Memorandum

Department of Planning & Development Services

RE: **Mobil Mart at Baxter and Clayton (Brite Worx)**: A Site Development Plan, Landscape Plan, Lighting Plan, Architectural Elevations and Architect's Statement of Design for a 1.72 acre tract of land zoned "PC" Planned Commercial District located on the western corner of the intersection of Clayton Road and Baxter Road.

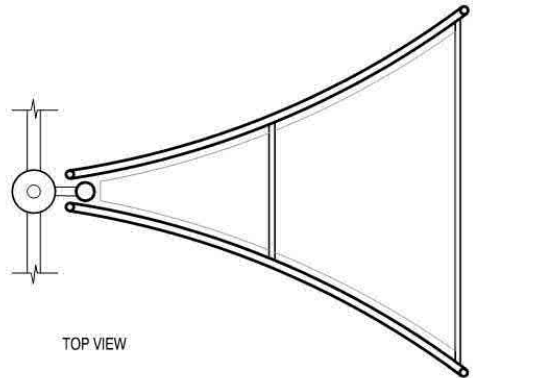
1. ARCHITECTURAL ELEMENTS

- a. Removal of the Accent Blue on the Aluminum cap on the Towers
- b. Eldorado Stone base changed from European Ledge in Linen to Rough Cut in Moonlight

- c. Upper material changed from Brick veneer to Eldorado Stone LedgeCut33® in Birch

- d. EIFS, in turn, changed to Prairie Clay-111 (which is similar to the Mia Sorella color that I understand ARB liked)

Previous Tommy Vacuum Station

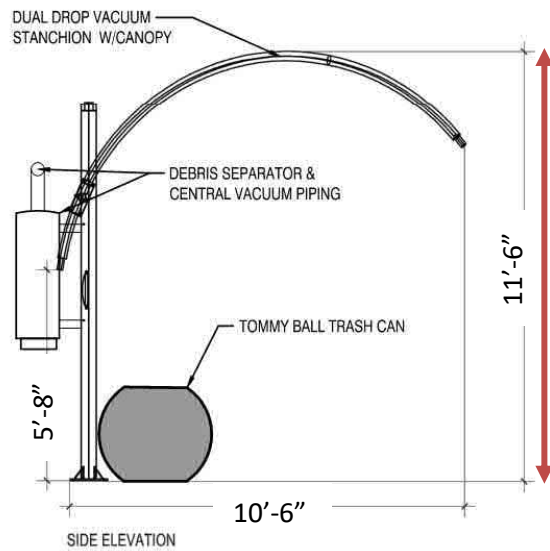
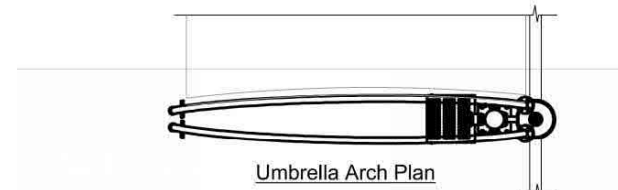
2. VACUUM STATIONS

- a. Remove all Blue elements that matched the accent blue on the building. All elements shall be grey.
- b. Vacuum Vendor

Figure 6: Screening Wall & Fence Locations

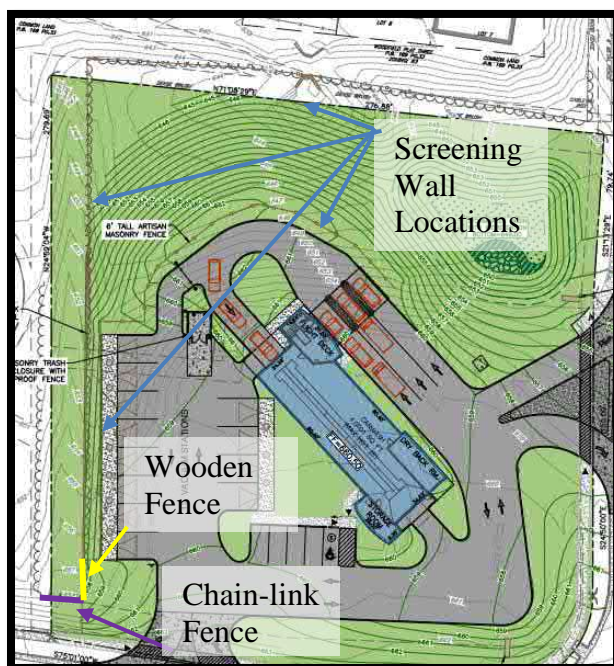
Per the requirements of Ordinance 2977, the site should have an artisan concrete screen wall along the western edge of the vacuum station that continues to wrap around the northern side of the drive aisle around the development. The Ordinance also has a requirement that an artisan concrete wall be installed along the northern property line. The Site Development Plan shows the required wall, along with an artisan concrete wall that connects the northern wall to where the wall turns at the vacuum stations, essentially providing a continuous wall along the western and northern property lines. The locations of these walls are indicated by blue arrows in Figure 6.

Figure 8: Columbia, Illinois Brite Worx Location at night

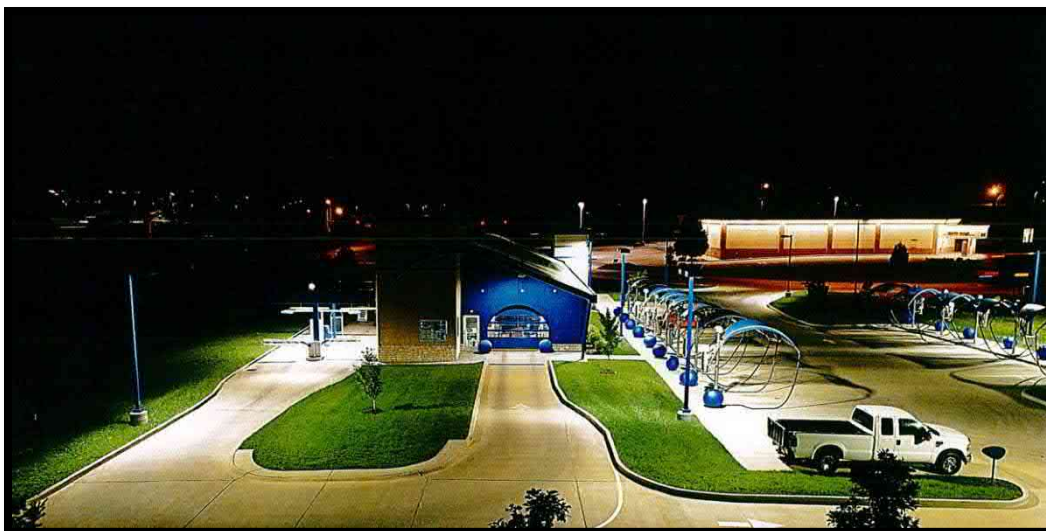
- **Provide photos of nighttime conditions to illustrate the appearance of the roofing material while lit at night.**

The applicant has provided photos of their location at Columbia, Illinois to demonstrate the amount of sky glow the clear roofing material would produce. All photos are included in the Commission's packet, and one can be seen in Figure 8, below.
